RE: Update on Structural Shoring for Damaged Roof Section
Ref. Drawings:
JM Albain Engineering, Dwgs S-1 to S-6 dated 10/25/10
Dwgs. S-6, S-7 rev. 1, (DCN #1) dated 01/26/11
Project # JMA10-327-06

DCN # 2

DRAWING No. **DC2-1**
 REV. 2
 By: J.M. Albaine, M.S., P.E.
 DATE: 02 / 05 / 11

Temporary Framing Inspection
REPORT #1 --- October 31, 2022

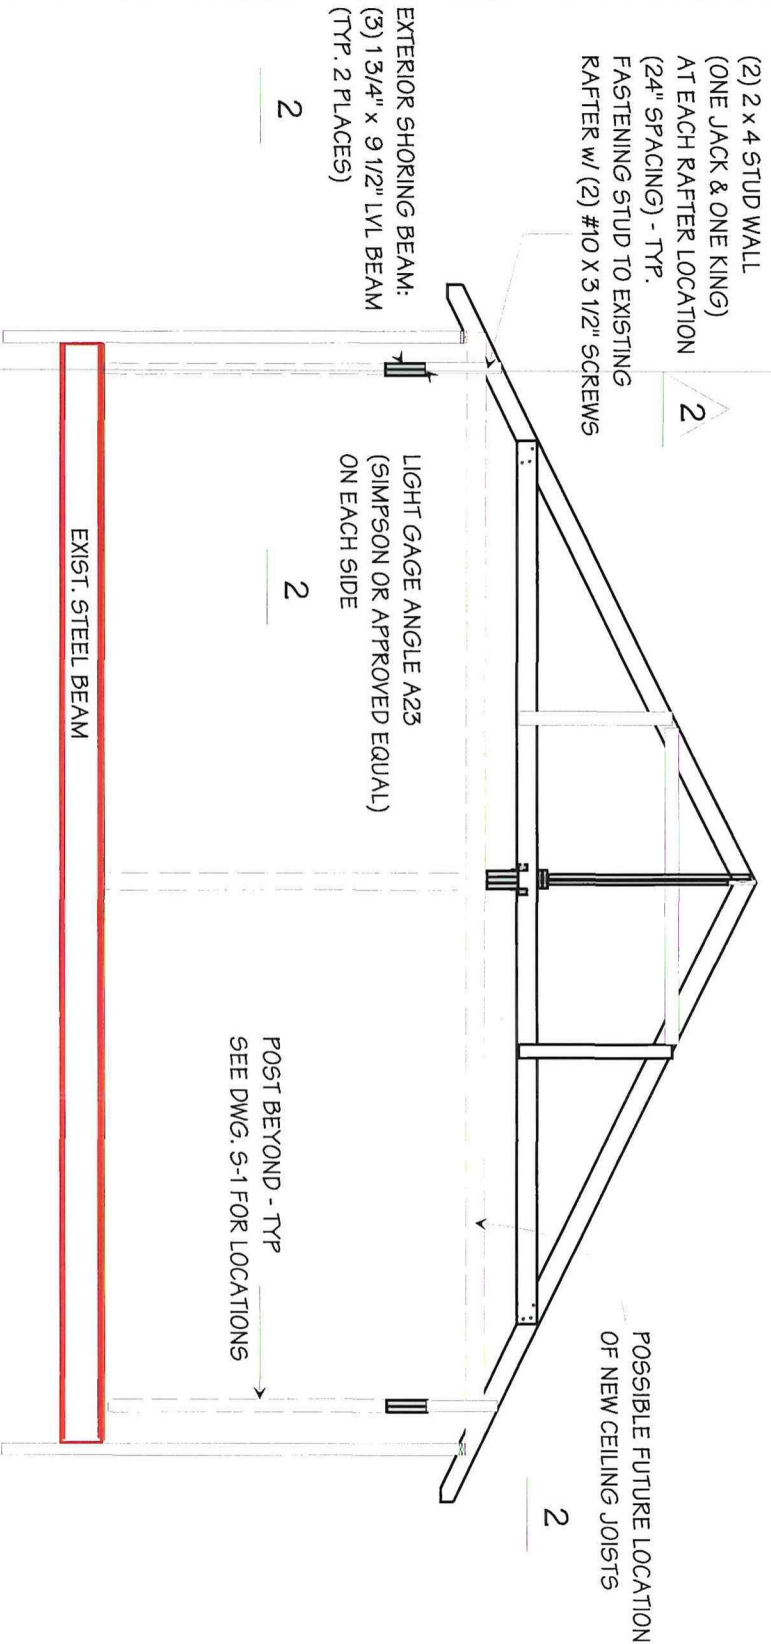
4. The new temporary roof supporting beams over the first floor Day Room and Kitchen will need to be increased to triple LVL's from double LVL's since we will need to cantilever those beams at each end of the room to avoid additional expensive work on the exiting features in the these rooms.

TEMPORARY SUPPORT BEAM: (3) 1 3/4 x 9 1/2" LVL

DRAWING No.
DC2-2

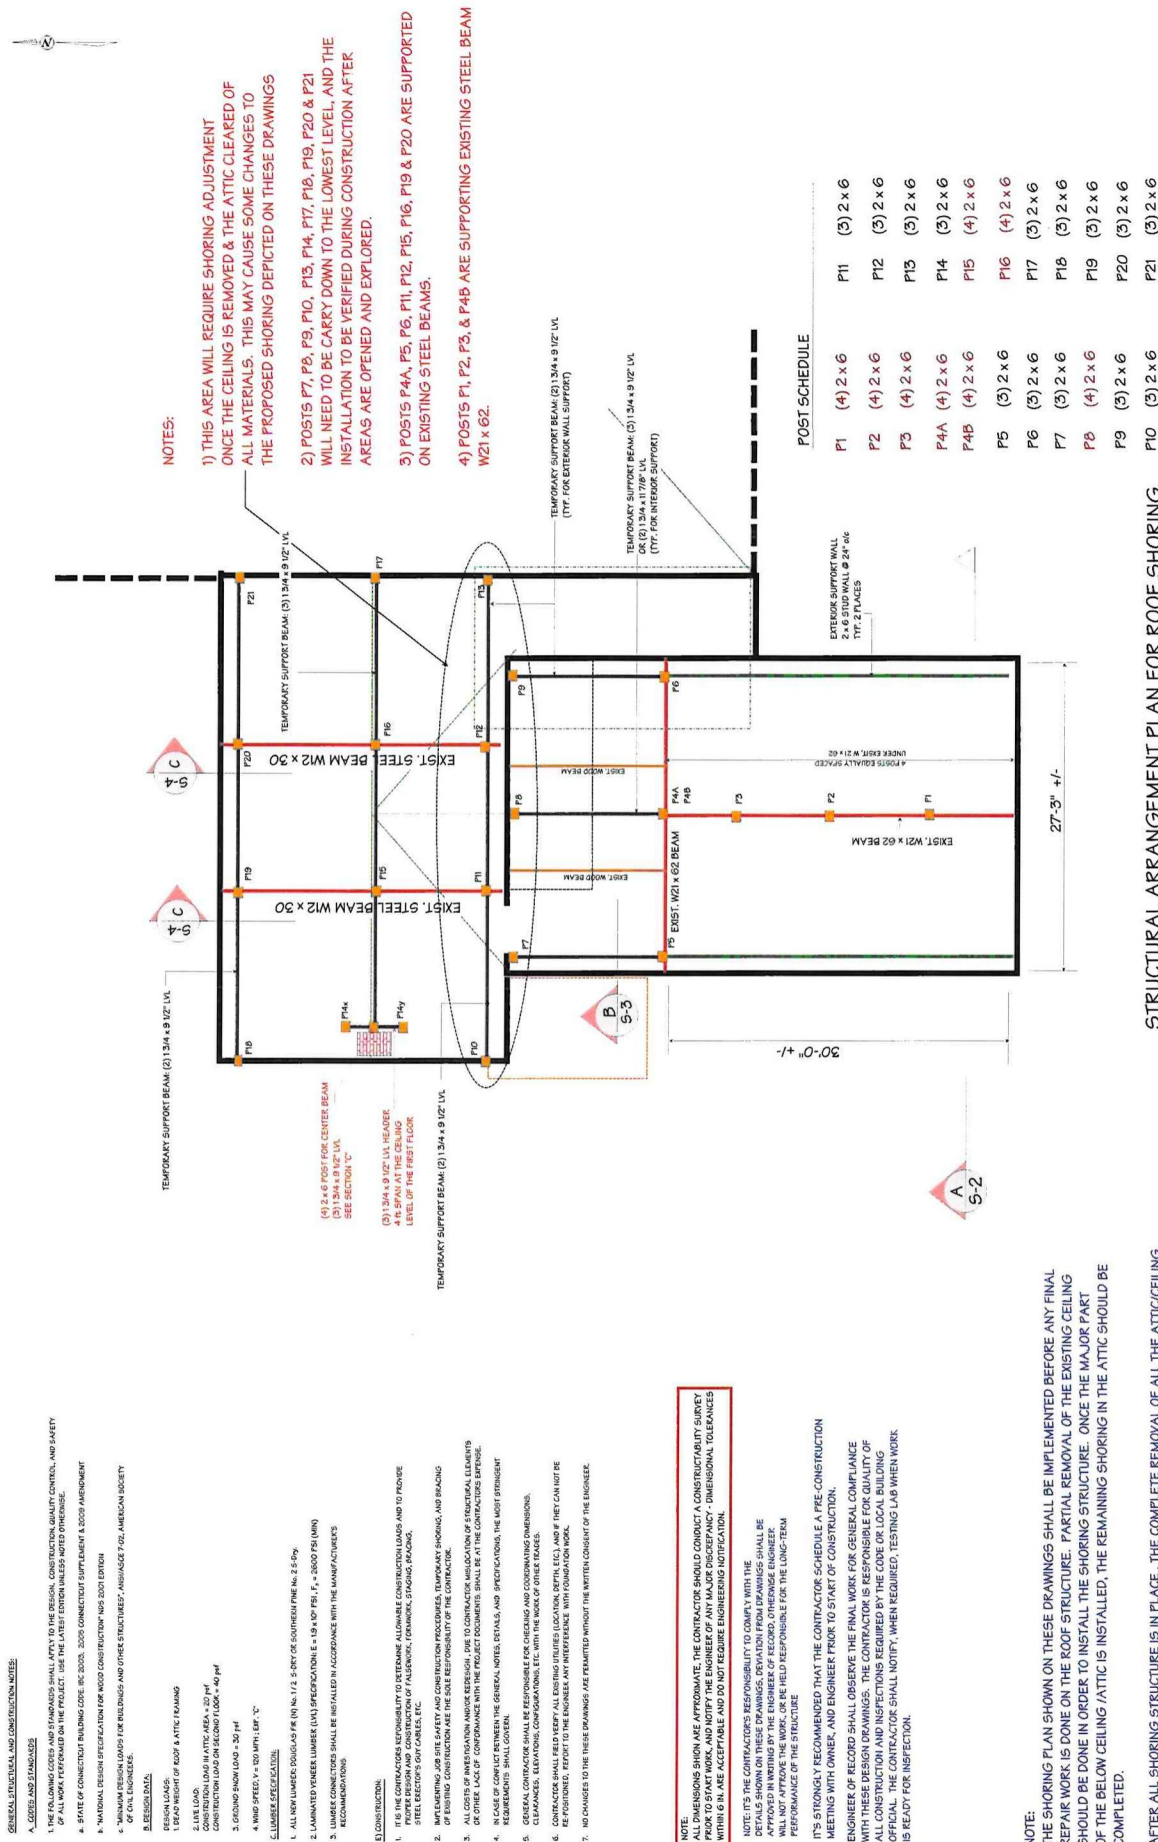
3. The temporary beams supporting the exterior edges of the roof, at both above the Hall Room and Kitchen (second floor, see Sections A, B, & C (Dwgs S-2, S-3 and S-4) will be installed at a lower elevation, with a short double stud (one king and one jack) above it, to make room for the potential installation of the future new ceiling joist.

THIS SECTION IS APPLICABLE FOR SECTIONS A, B, & C

FOR SECTIONS A & B (DWGS. S-2 & S-3), THE EXTERIOR BEAMS
ARE: (2) 1 3/4 x 9 1/2 LVL

FOR SECTION C (DWG. S-4) ALL THE BEAMS ARE (3) 1 3/4 x 9 1/2" LVL

DWG. No.	S-7
REV.	2

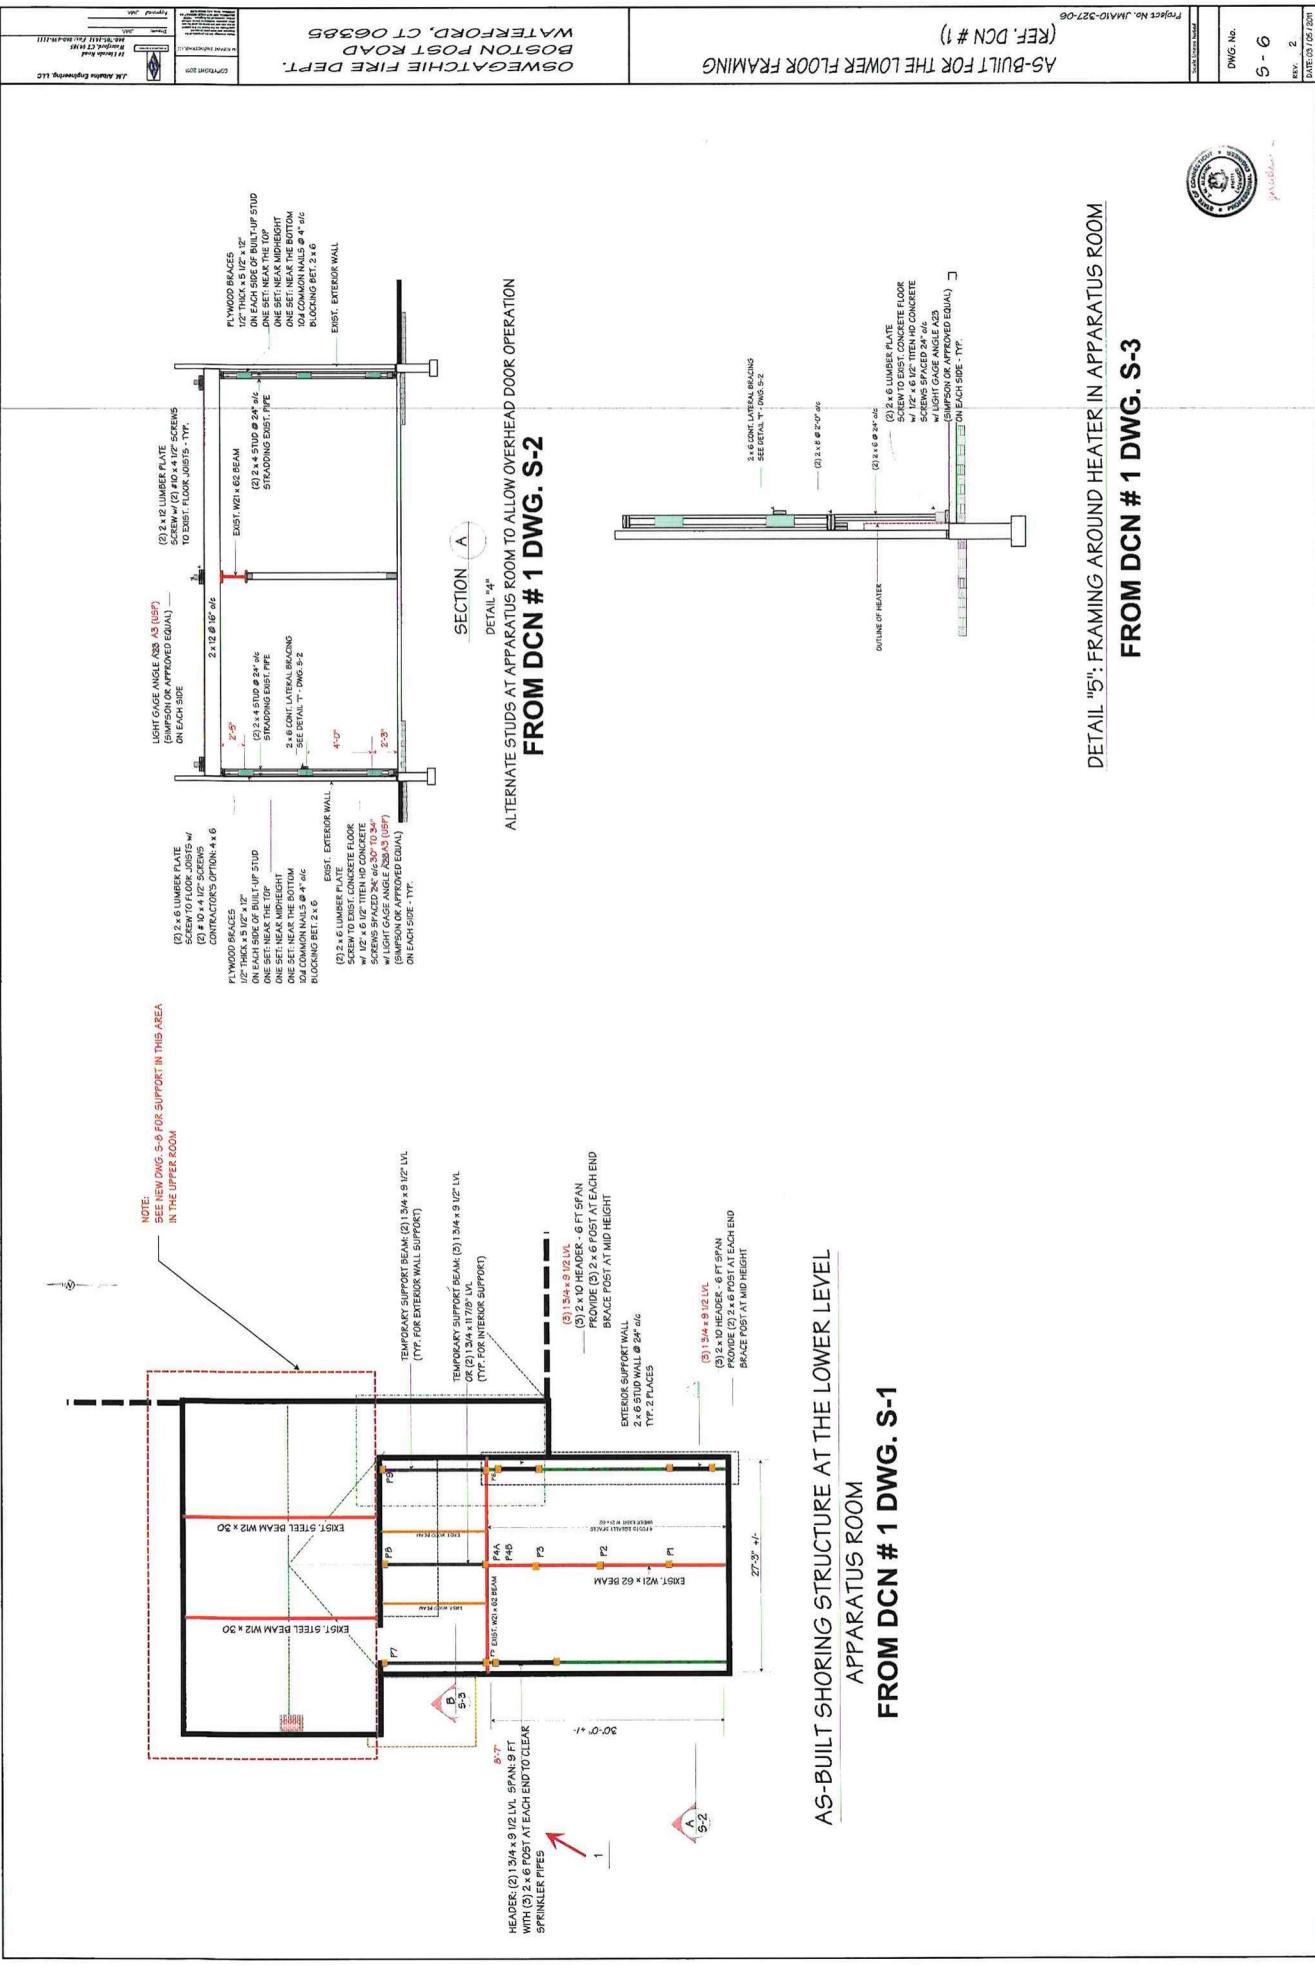
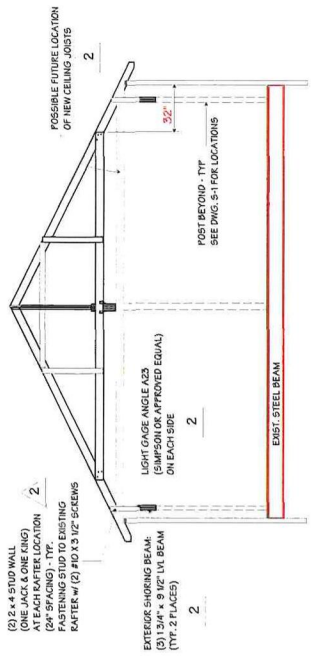
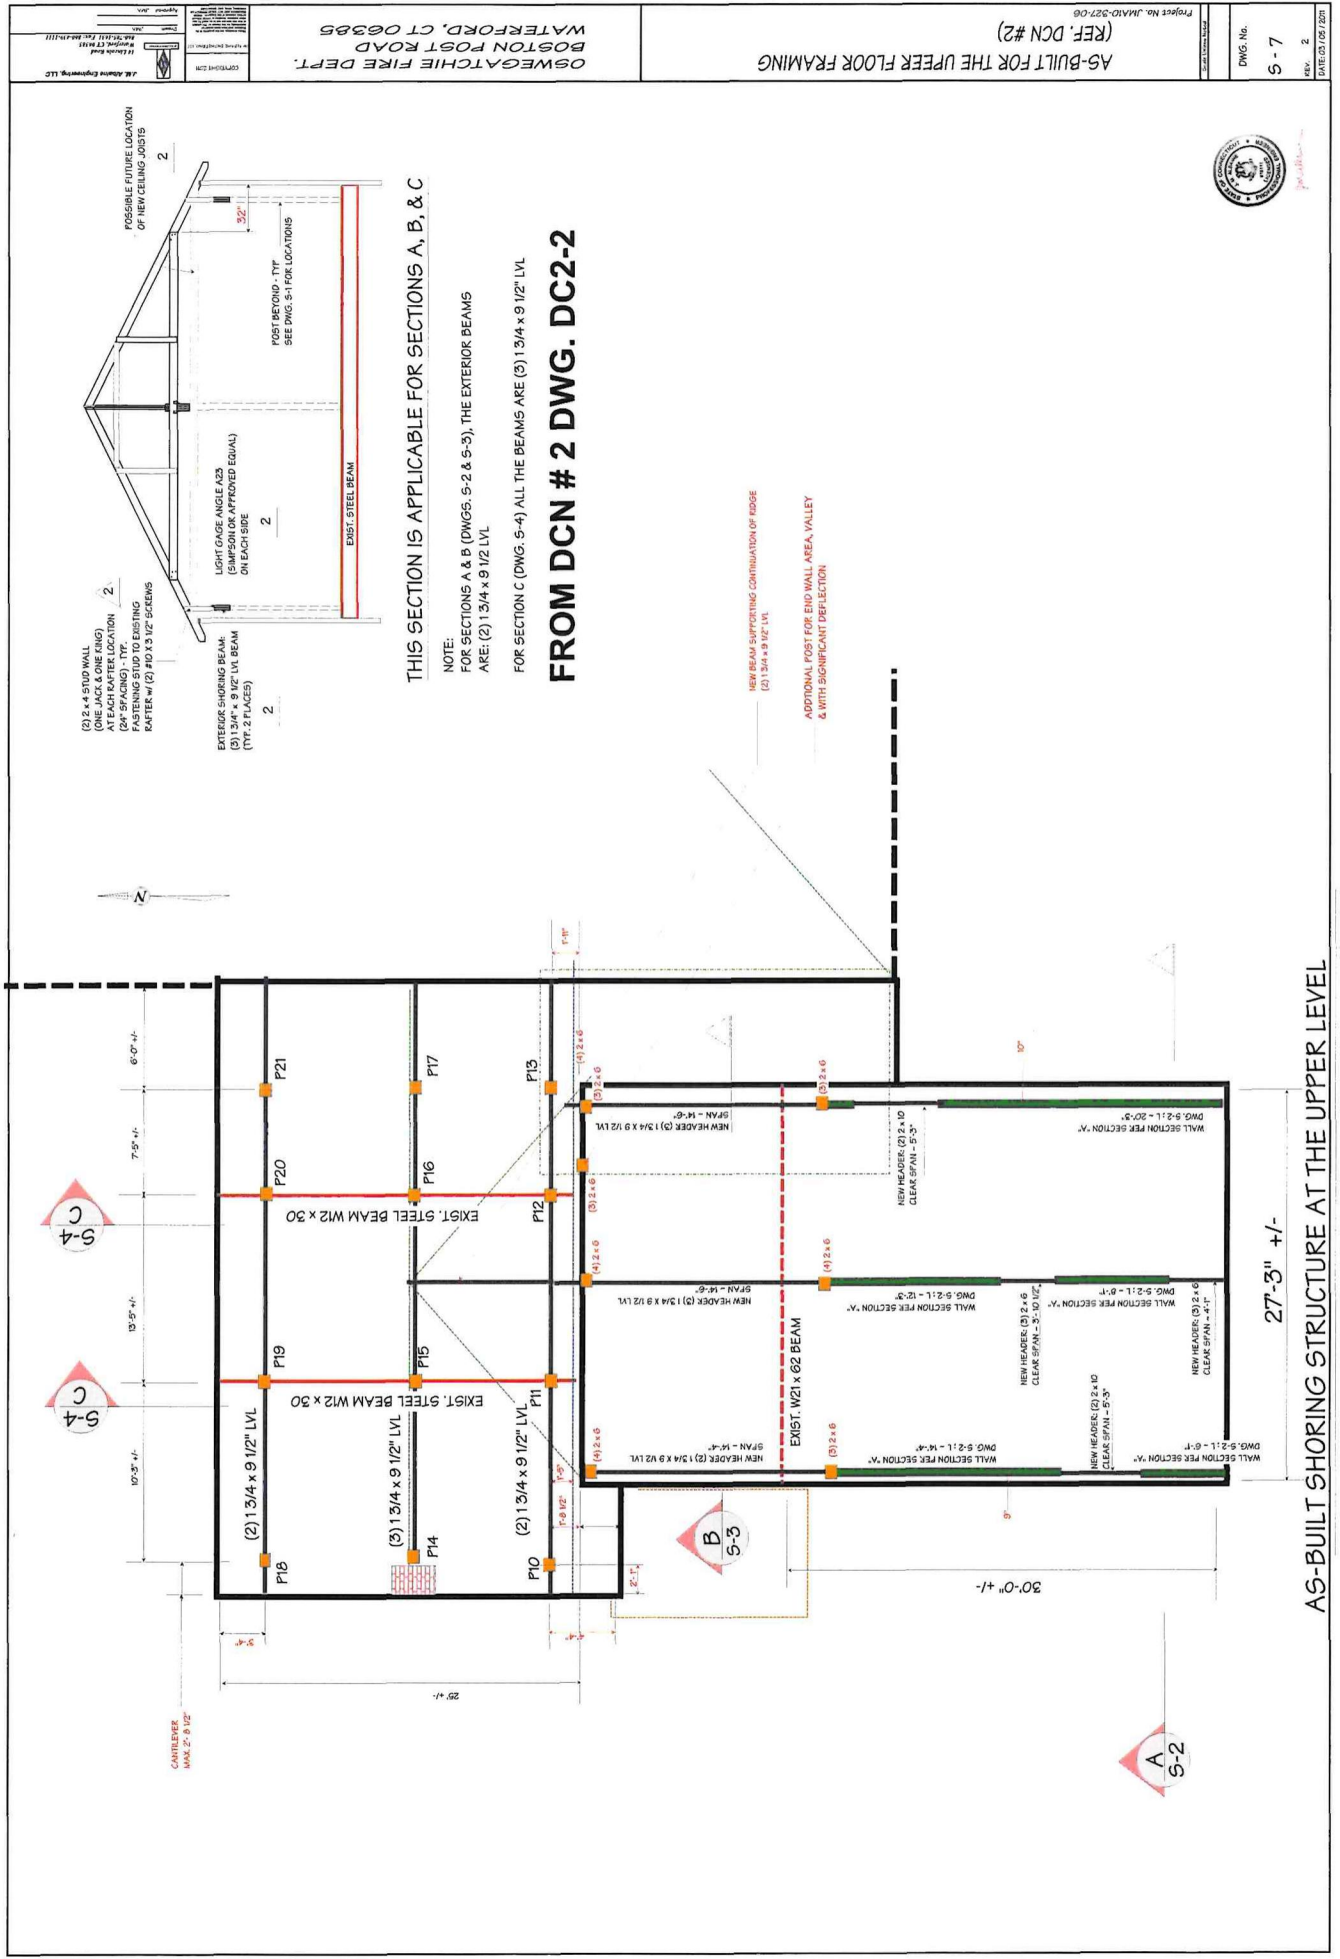
CONCEPTUAL DESIGN FOR ROOF REINFORCEMENT
(FOR PRELIMINARY CONSTRUCTION ESTIMATE COST)

NOTE:
 FOR SECTIONS A & B (DWGS. S-2 & S-3), THE EXTERIOR BEAMS ARE: (2) 1 3/4 x 9 1/2\"/>

FOR SECTION C (DWG. S-4) ALL THE BEAMS ARE (3) 1 3/4 x 9 1/2\"/>

NEW BEAM SUPPORTING CONTINUATION OF RIDGE
 (2) 1 3/4 x 9 1/2\"/>

ADDITIONAL POST FOR END WALL AREA, VALLEY & WITH SIGNIFICANT DEFLECTION
